## Technical bulletin:

Updating AGCO RG-C Series sprayers to CapView Software version 4.18 requires a modification to the Chassis Harness PN 118669-050

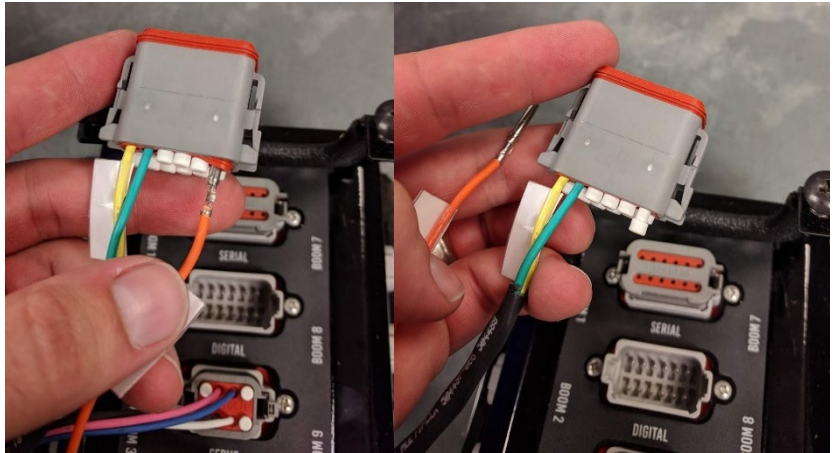
1. Make sure the machine is powered off and that the battery disconnect has been tripped.
2. Remove the cover from the Gateway hub.
3. On the Gateway Hub, remove the 12-pin Deutsch connector in the DIGITAL port.

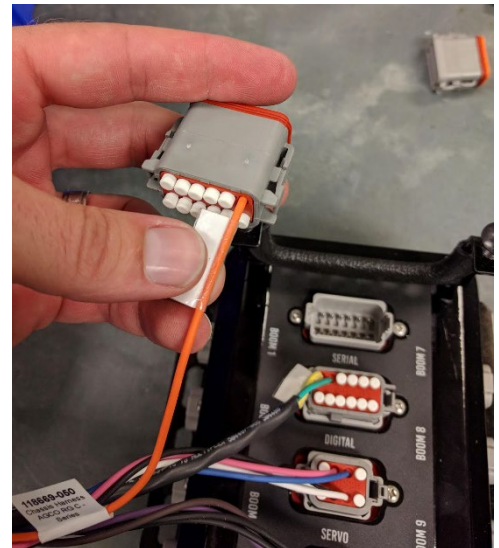
4. Remove the wedge lock from the male connector on the harness side.
5. Remove the orange wire from the connector.
6. Replace the open hole with a white Deutsch plug and insert the wedge lock.
7. Install the connector into the DIGITAL port on the Gateway Hub.

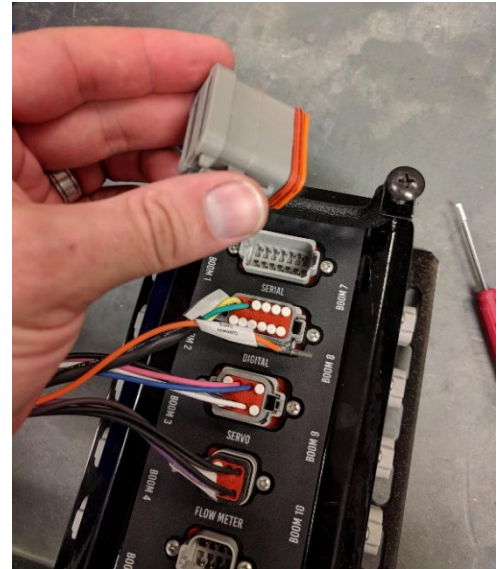
8. Take a 12-pin Deutsch DT male connector and install the orange wire into the pin-6 location and plug all other pin locations.
